ADDENDUM

Addendum: No. 2
Tender no: RFT-DRK-17-005-0
Date: June 6th, 2017
Re: Daycare Renovation at Kanata Public Elementary School

Addendum No. 1

Architectural Addendum No. 1

6 PLAN: RAISED FLOOR
S101 SCALE 1:25

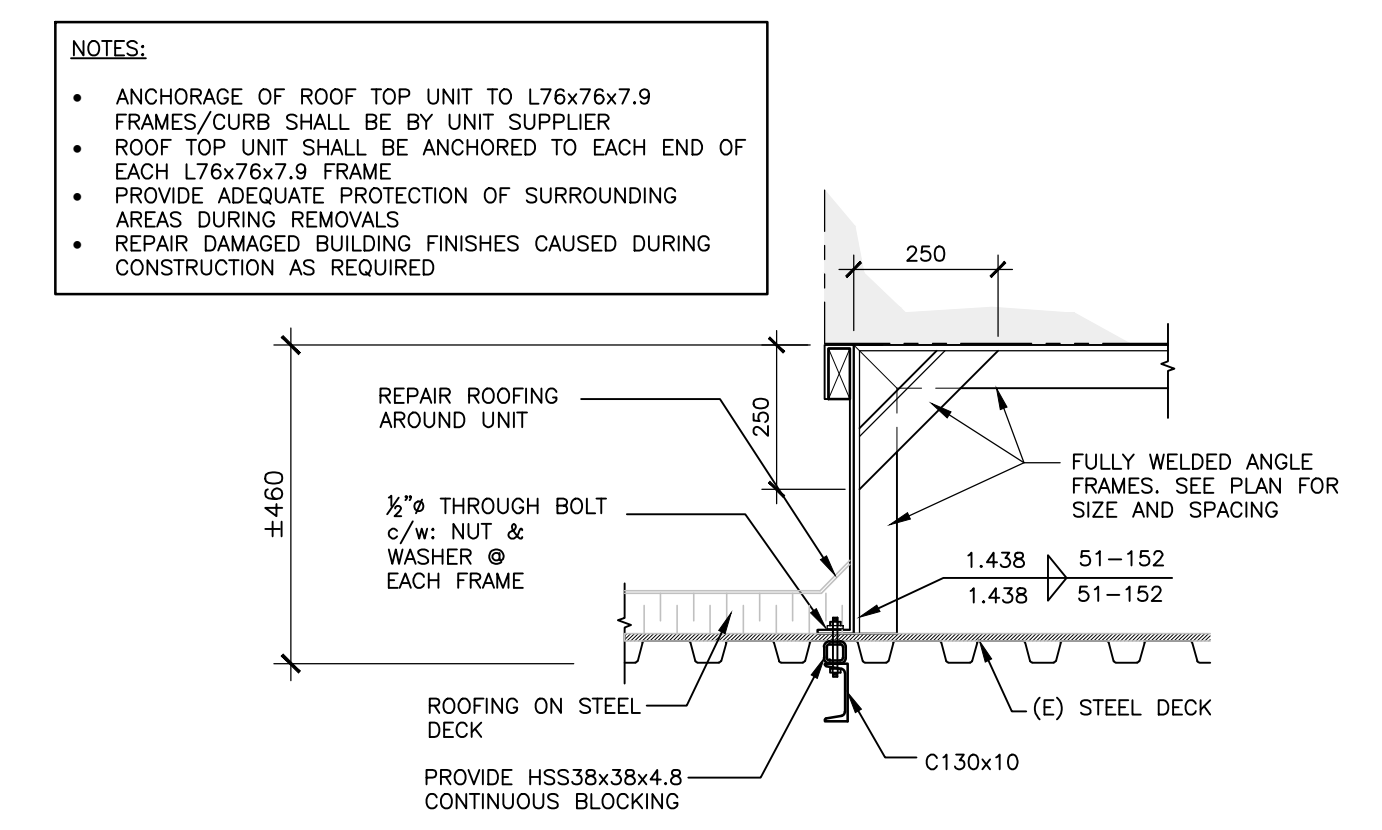
2. **ADD S1 S101:**
 - a. Provide new structural steel framing around edges of openings and edges of unit for new roof top unit and new roof top exhaust fan.
 - b. Provide seismic reinforcing for new roof top unit curb.
 - c. Provide new raised floor comprised of concrete on composite steel deck supported on cold-formed steel joists bearing on cold-formed steel stud walls.
 - d. Provide new concrete slab on grade.

DRAWN:	J. PILON	DRAWING No.	ADD S1
DESIGNED:	G. FALCOMER		S101
APPROVED:	B. WEATHERDON		
DATE:	JUNE 02/17		
SCALE:	AS SHOWN		
PROJECT No:	17-2168

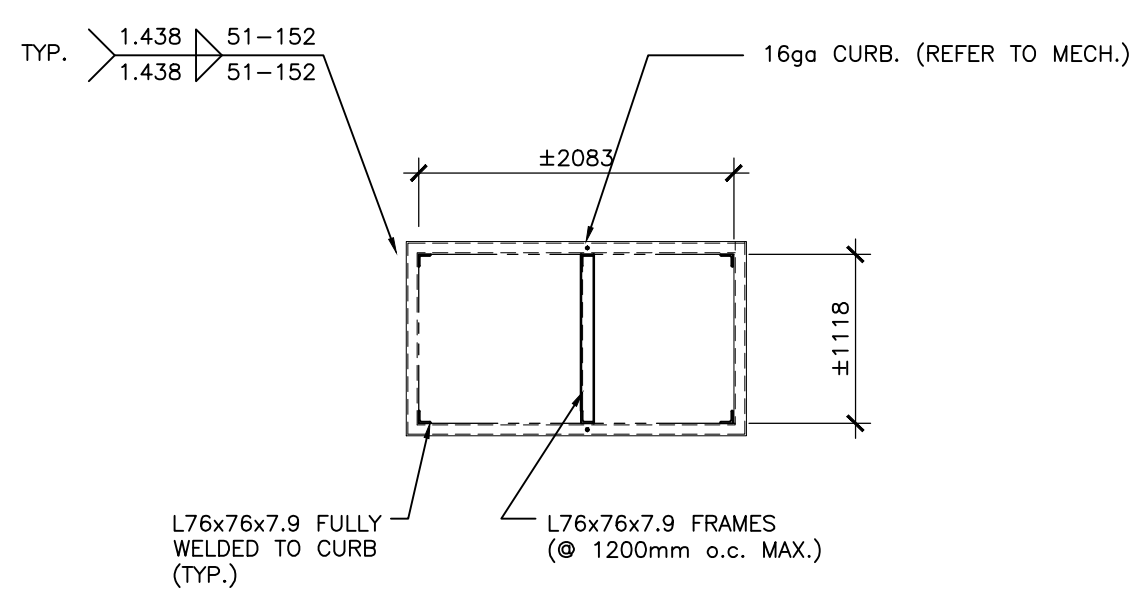
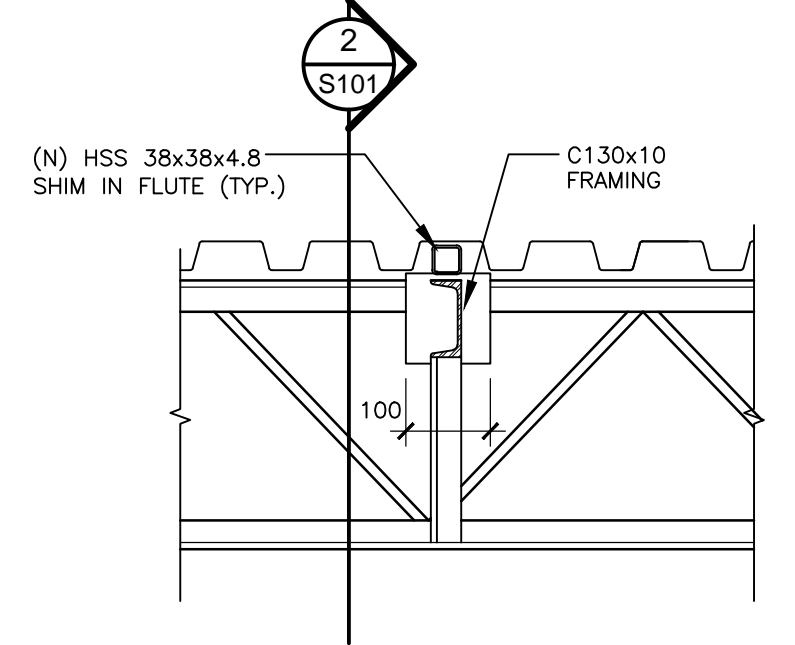
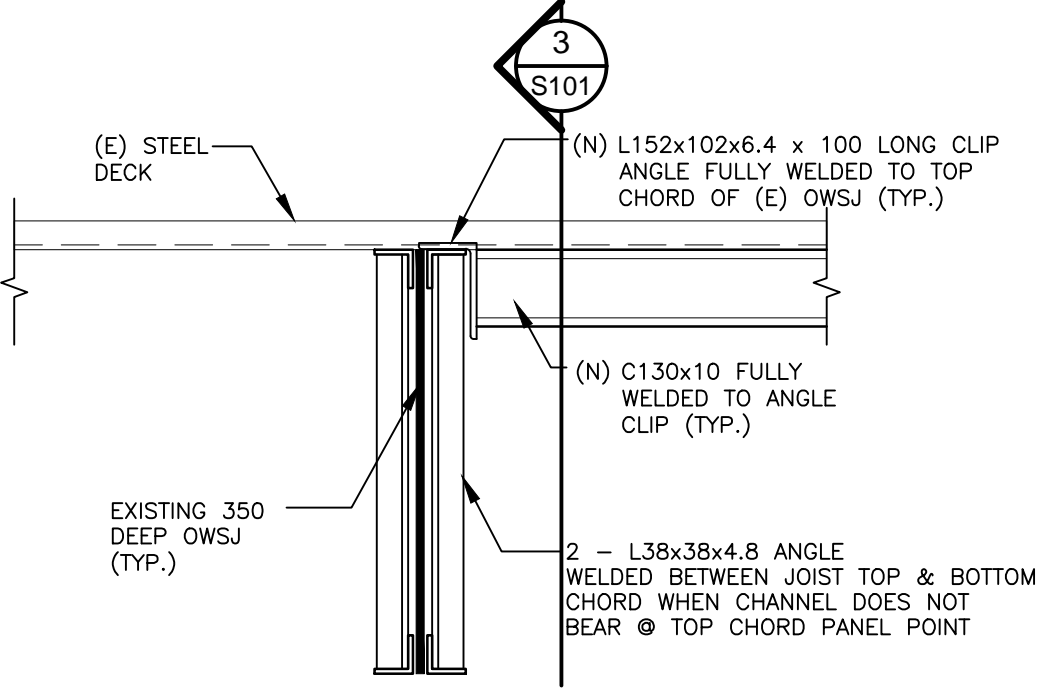
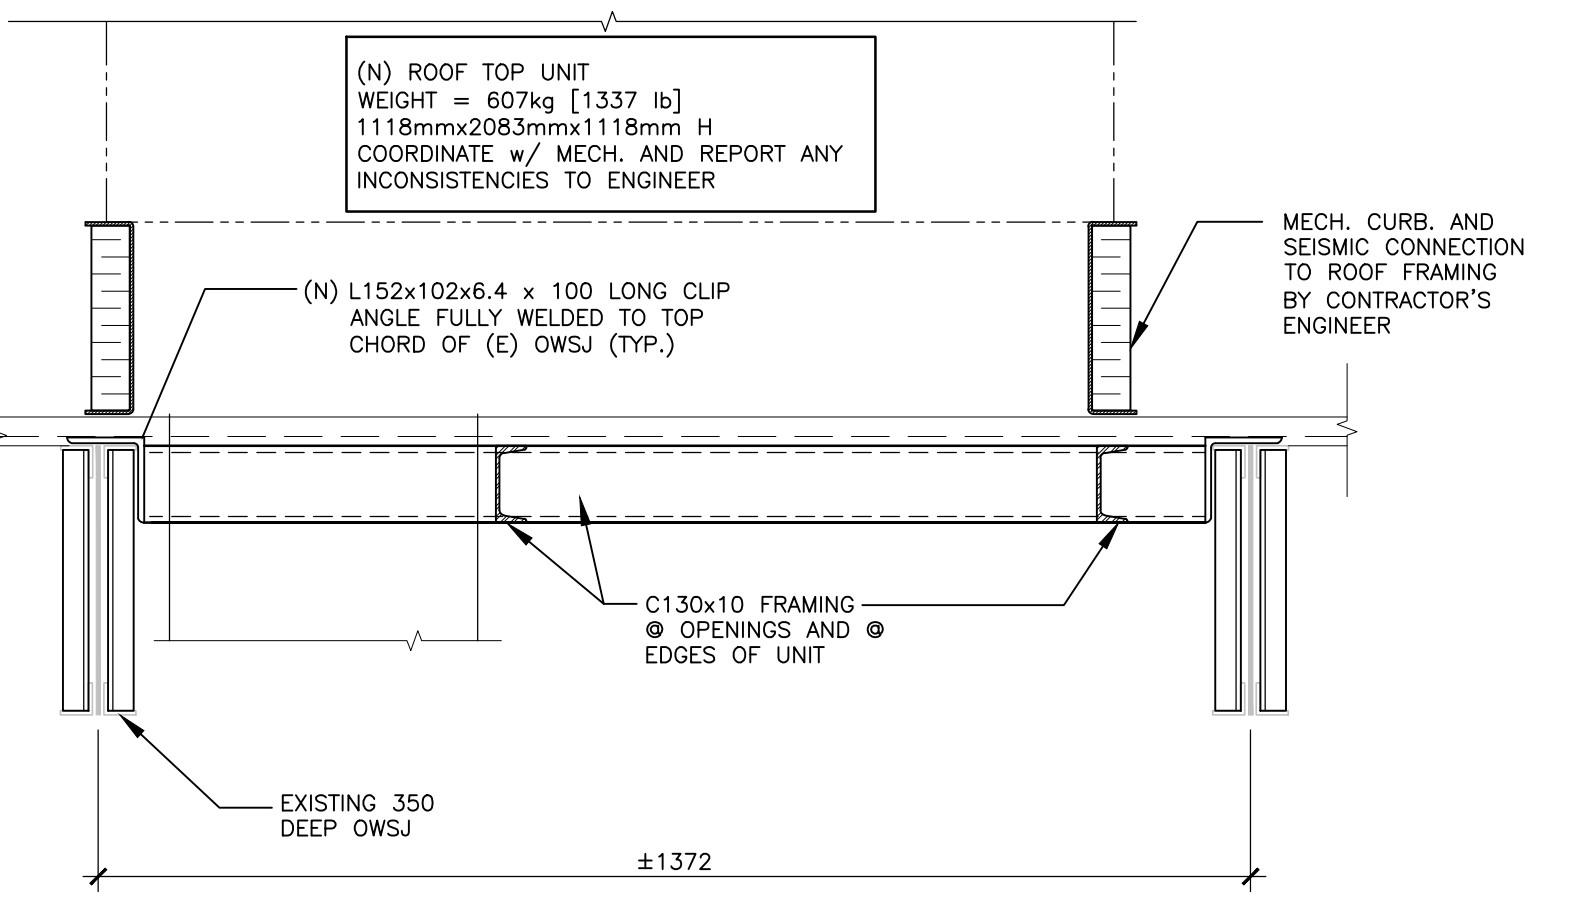
1. **ADD S1 S100:**
 - a. Provide new structural steel framing around edges of openings and edges of unit for new roof top unit and new roof top exhaust fan.
 - b. Provide seismic reinforcing for new roof top unit curb.

PROJECT No	8017-014	PROJECT ÉCOLE ÉLÉMENTAIRE PUBLIQUE DE KANATA DAYCARE		
FILE	91-			
DATE	2017-06-02	REFERENCE DRAWING	M-2GF-3	REVISION 1
BY	P. CORLUKA	SCALE	1:100	EXCERPT No SKE-3

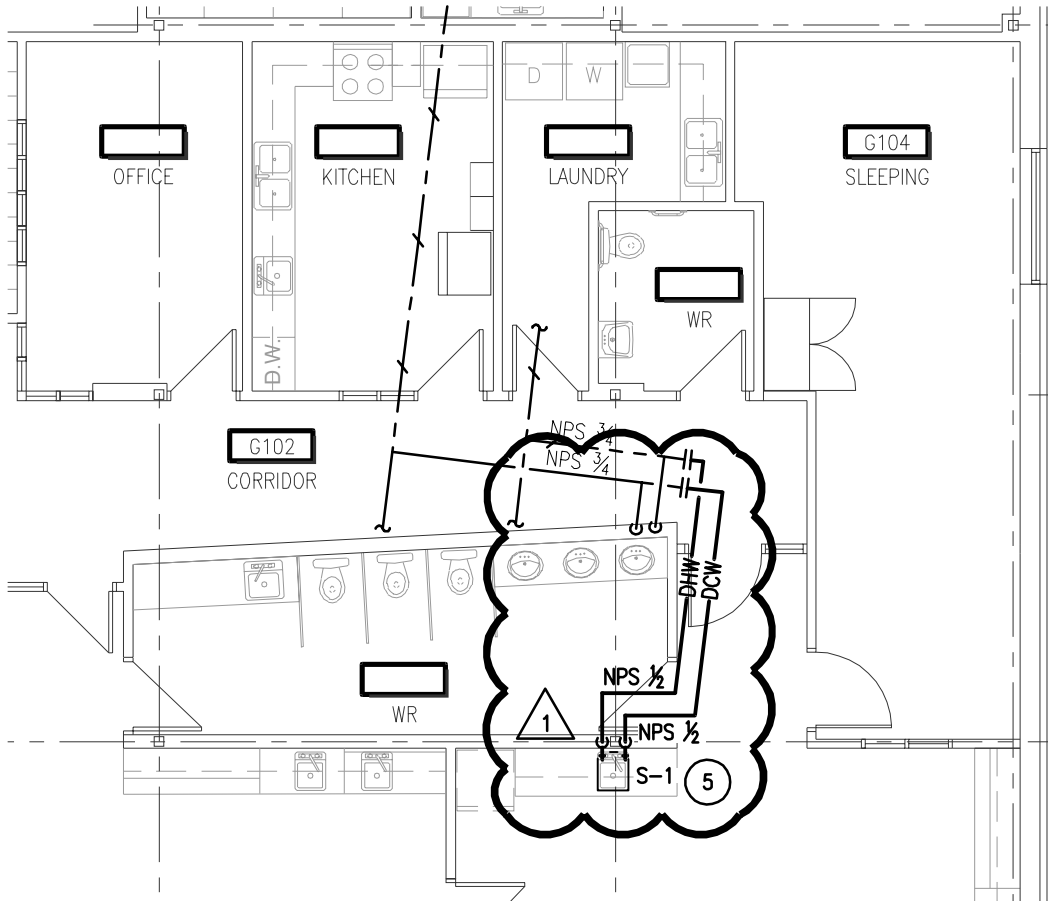
Description: Addition of a sink in the daycare

- CONSTRUCTION NOTES:**
- ① EXISTING WATER ENTRANCE CAPPED AT THE SLAB LEVEL.
 - ② NEW WATER HEATER INSTALLED IN CEILING SPACE. REFER TO THE CONNECTION OF A WATER HEATER INSTALLED IN CEILING SPACE DETAIL ON DRAWING M-101.
 - ③ NEW NPS-2 WATER METER INSTALLED AS PER MANUFACTURER'S INSTRUCTIONS. CONTROL WIRING FOR THE MONITORING OF WATER CONSUMPTION TO BE RECONNECTED.
 - ④ EXISTING VERIS INDUSTRIES'S MEASURING DEVICE RE-INSTALLED.
 - ⑤ SUPPLY AND INSTALL NEW SINK, C/W THERMOSTATIC MIXING VALVE.
